Technical Note

Project: Proposed Residential Development off Pitt Street, Wombwell (2019/1117)

Title: Road Safety Audit (RSA1) – Designer's Response

STAGE 1 ROAD SAFETY AUDIT

- Extract from drawing: 200226_SK22001_TN01(-00) Pitt Street, Wombwell, Proposed Site Access General Arrangement

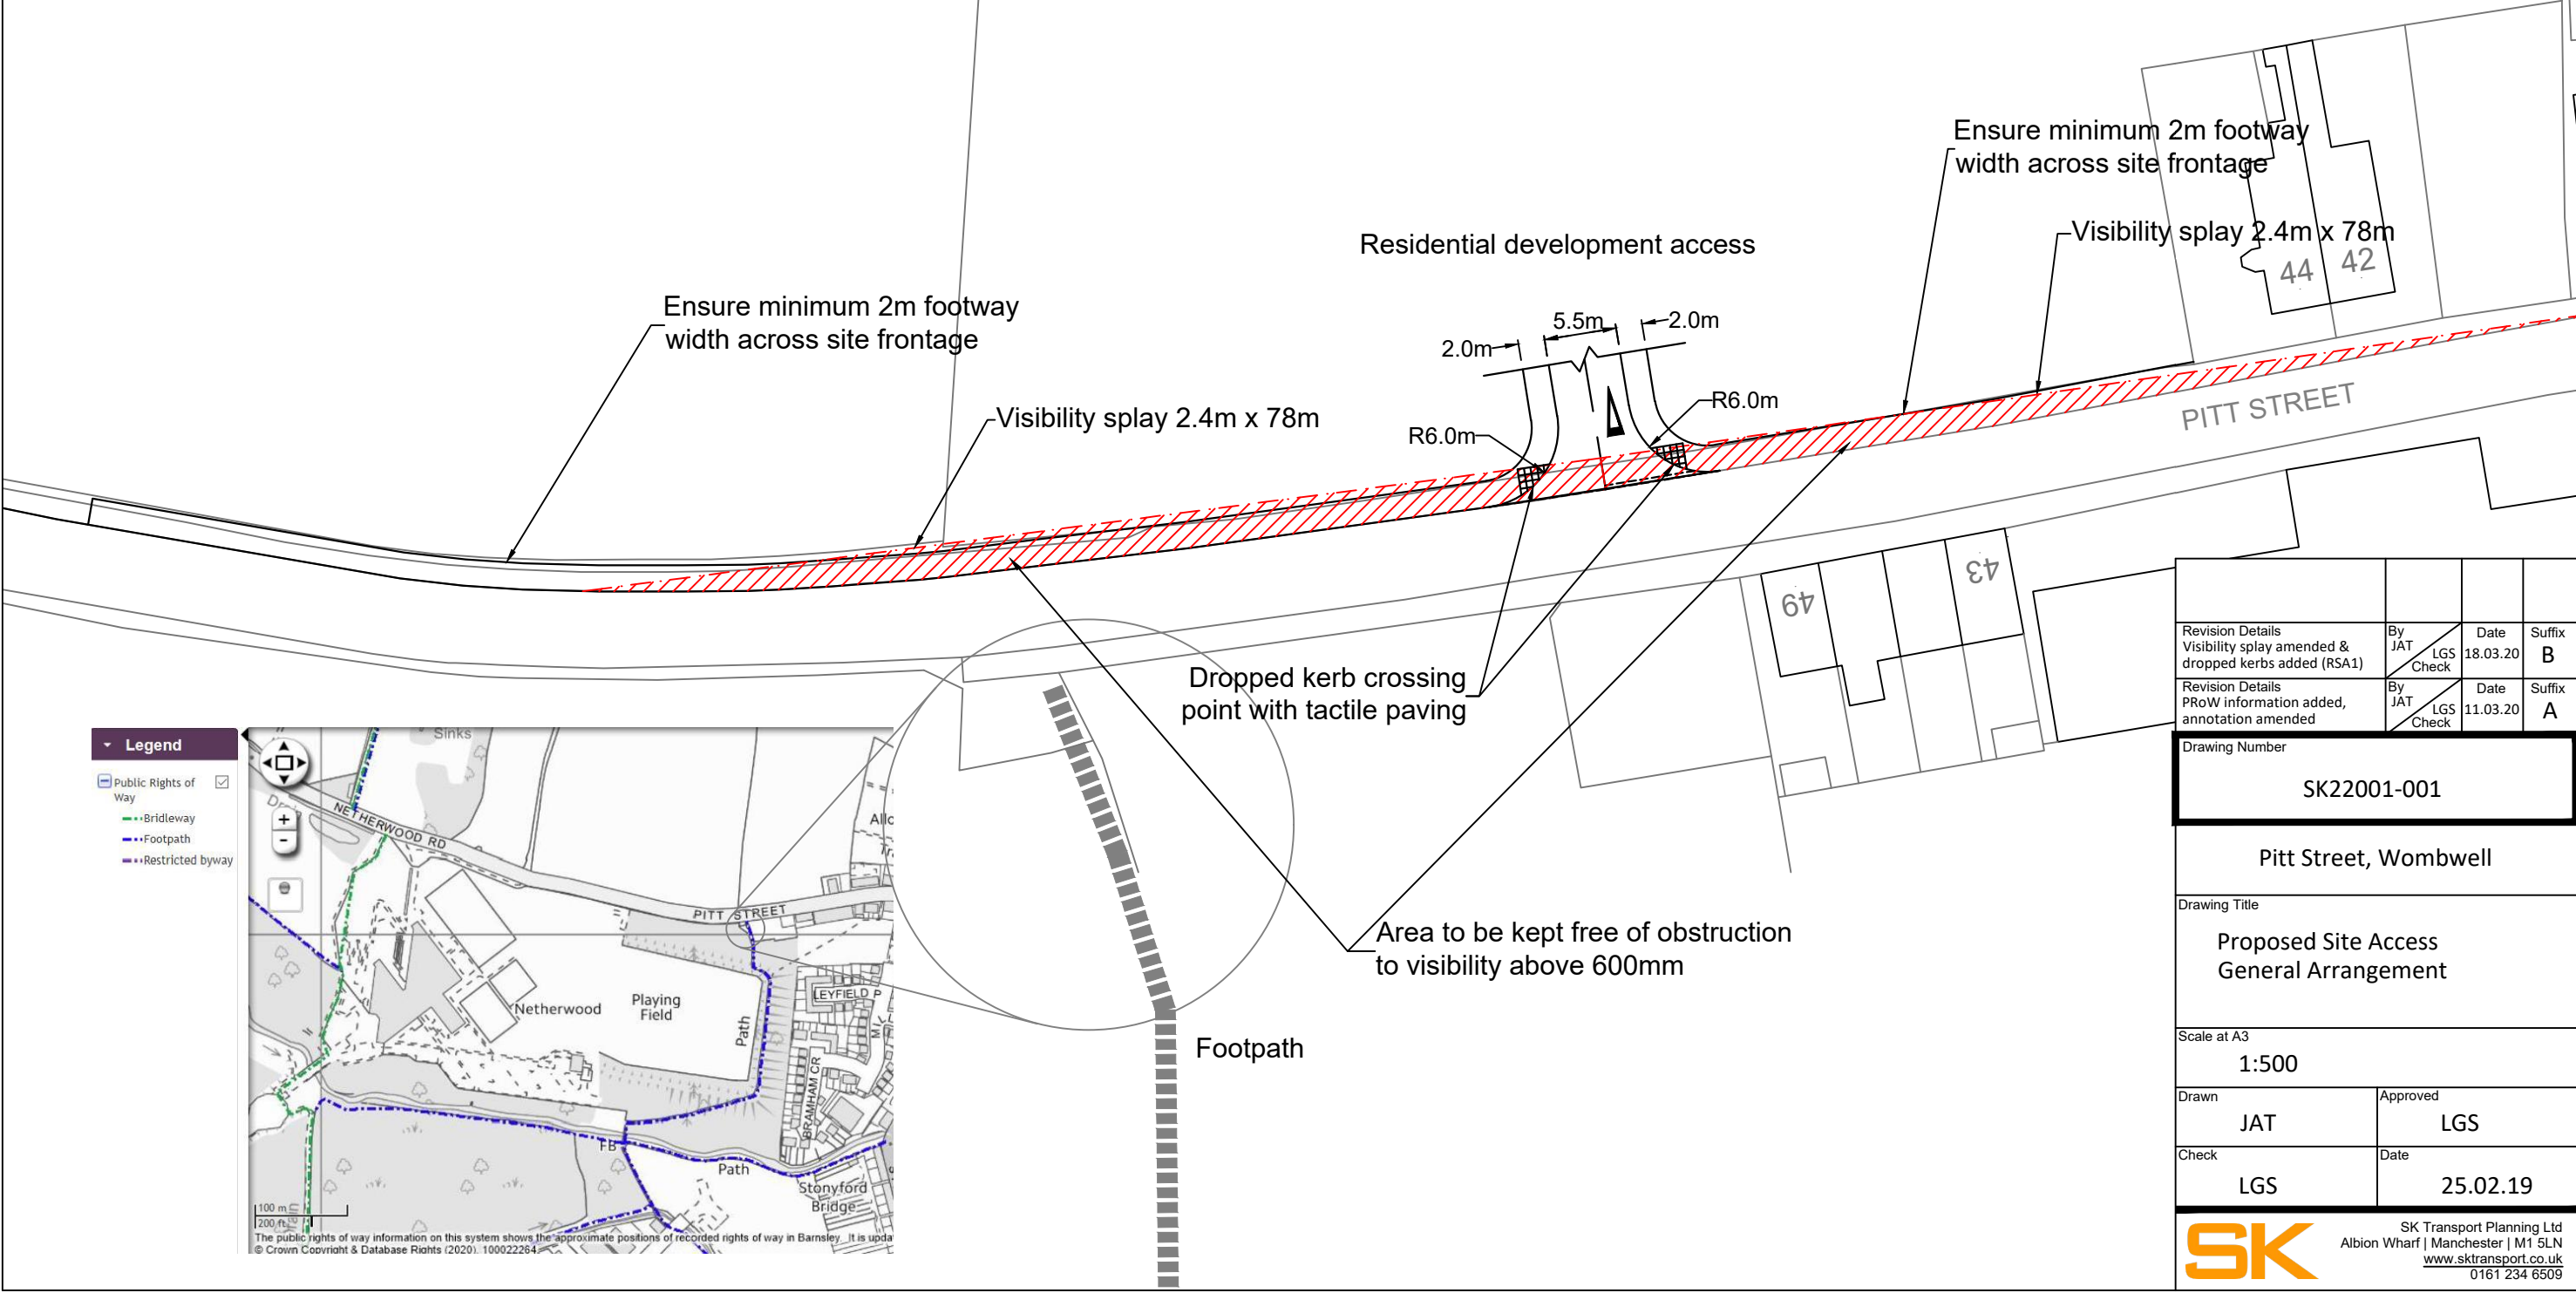
The proposed footway layout on both sides of the access junction does not appear to include pedestrian crossing facilities. There is a risk that pedestrians attempting to cross the new access junction would be forced to negotiate full height kerbs without the aid of tactile markers to guide them. This could lead to a risk of trips and falls and may pose a particular difficulty for pedestrians with sight impairment.

It is recommended that pedestrian crossing facilities inclusive of dropped kerbs and tactile paving be included in the detailed design of the new access junction.

The historical accident data close to the site indicates a cluster of accidents occurred in the five-year period between 2013 and 2017, a number of which resulted in serious injury and more than half of which involved children being struck by vehicles. Data submitted to the Audit Team suggests that the mean of the 85%ile surveyed speed is between 36 and 37 mph. Whilst the general design of the access junction layout appears to be broadly consistent with design guidance set out within Manual for Streets, the 85%ile speeds suggest that some vehicles may significantly exceed the speed limit. The cluster of accidents may support this. Consequently, it may be that the design – including visibility, etc - should be adequate for a higher speed. If drivers leaving the access do not see approaching vehicles, then they may pull out into live traffic, resulting in a side-on collision.

It is recommended either that the scheme is designed with parameters appropriate to a higher speed limit, or that measures are implemented to ensure that the speed of vehicles passing the access is such that the design operates safely.

- 2.3 The proposed access junction has been amended to include dropped kerbs and tactile paving at the access junction. The updated layout is attached as Appendix B.

- 3.4 The visibility required at the access has been calculated in line with the design guide method set out in Manual for Streets using speed survey data.
- 3.5 Notwithstanding the above, a review has been made of the visibility available and the splay adjusted to 78m based on the formula for 45mph design speed. This is shown in Appendix B.
- 3.6 The adjustment has been discussed with the auditor who has confirmed that this is satisfactory. Confirmation of this is attached as Appendix C.

- 3.7 To accommodate this visibility, all boundary treatments and/or landscaping within the splay will be maintained at a height below 600mm.
- 3.8 The width of Pitt Street limits the opportunities to introduce other design measures to reduce speeds at the access. However, the visibility splay has been increased as recommended.
